Ref: 208-20-DE-REV-00

1 December 2020

**12-14 Birnie Avenue, Lidcombe
Review of Windtech Pedestrian Wind Environment Study
Windtech Document Number: WE430-01F03(REV0)-WE Report**

Figure 1: Test locations from Windtech Report Figure 6a located on Windtech Report Figure 6b

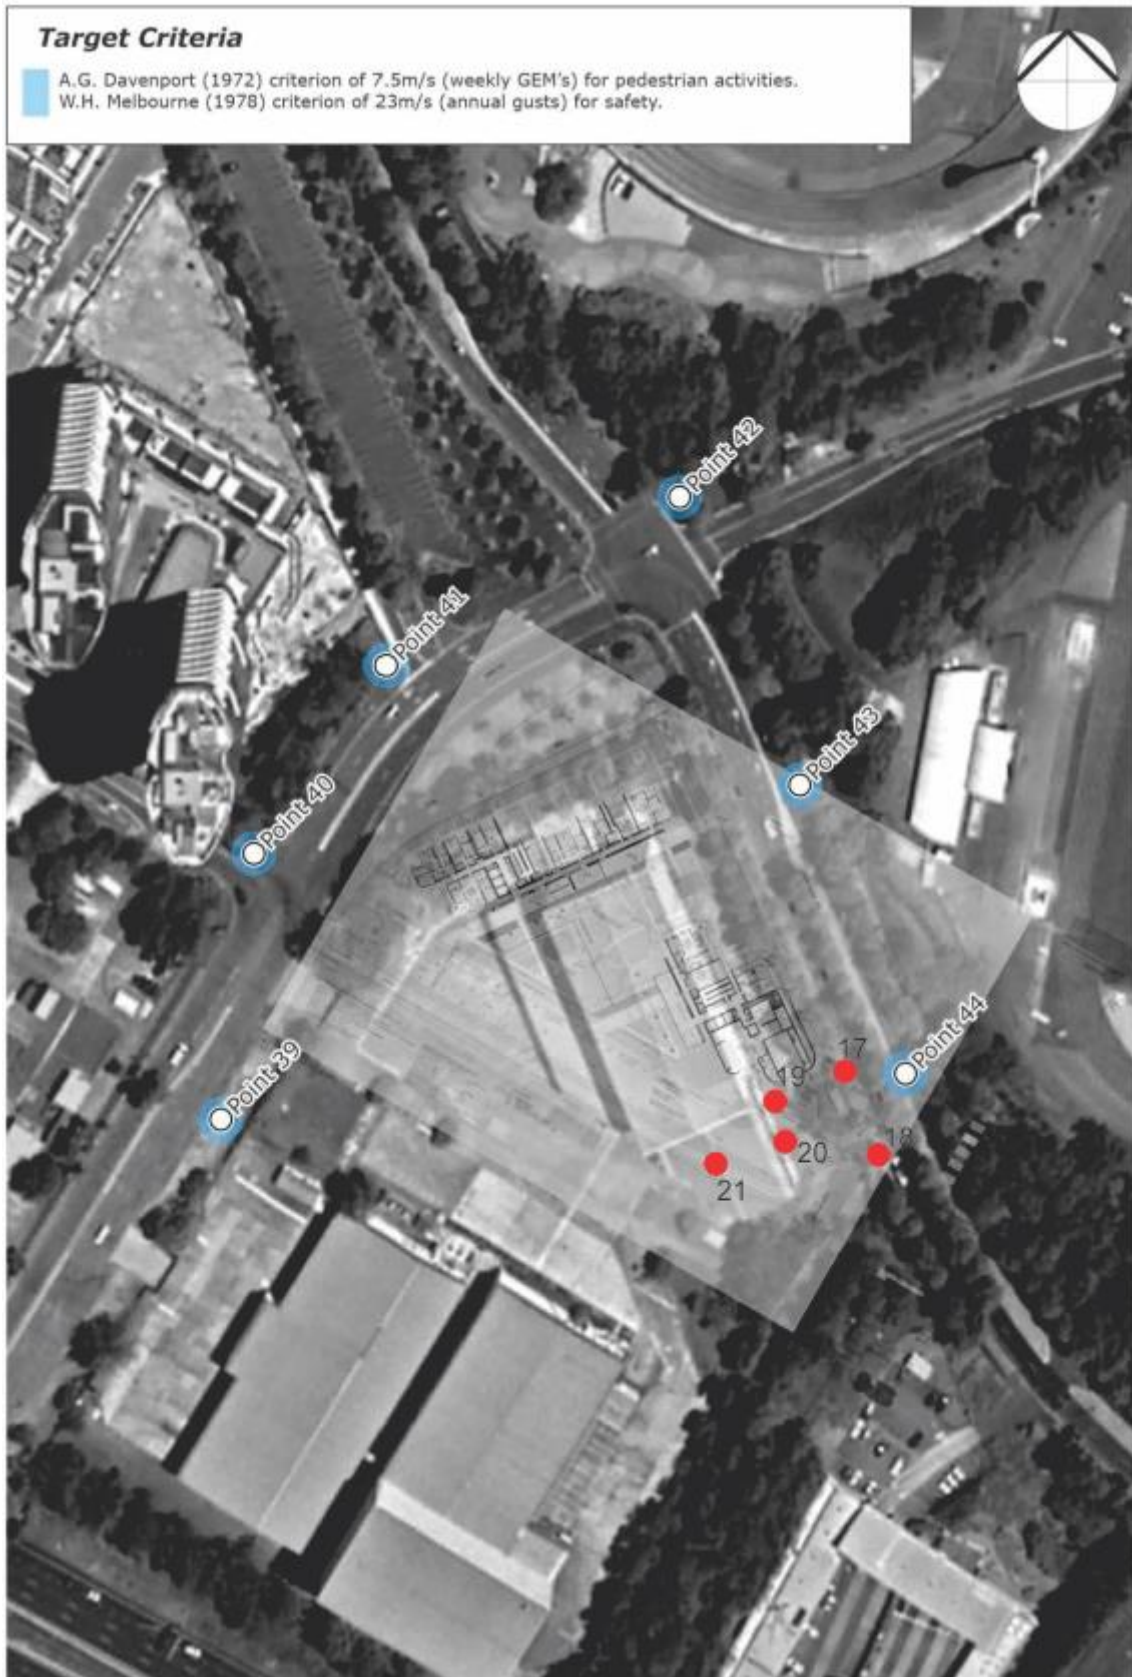
- Windtech have shown for the Existing Configuration a number of locations exceed the safety criterion and this is unexpected for the Industrial Warehouse, particularly at the lower height south end. Figure 1 presents Figure 6b from the Windtech report with the Study Locations at the south end of the building from Figure 6a of the Windtech report. The positions of the Study Locations have been determined by comparing Figures 6a and 6b, since Windtech overlayed the ground plan in Figure 6b. Windtech determined for the Existing Configuration that Study Locations 19, 20, and 21 have wind conditions that exceed the safety criterion. Based on the locations in Figure 1, Study Location 21 is on the roof and Study Locations 19 and 20 are on the east side of the existing building. Windtech need to provide an explanation for the high wind speeds measured at Study Locations 19 and 20 on the east side of the low-rise section of the existing building away from the influence of tall buildings.

Furthermore, these locations are not near the building corner where wind acceleration would be expected.
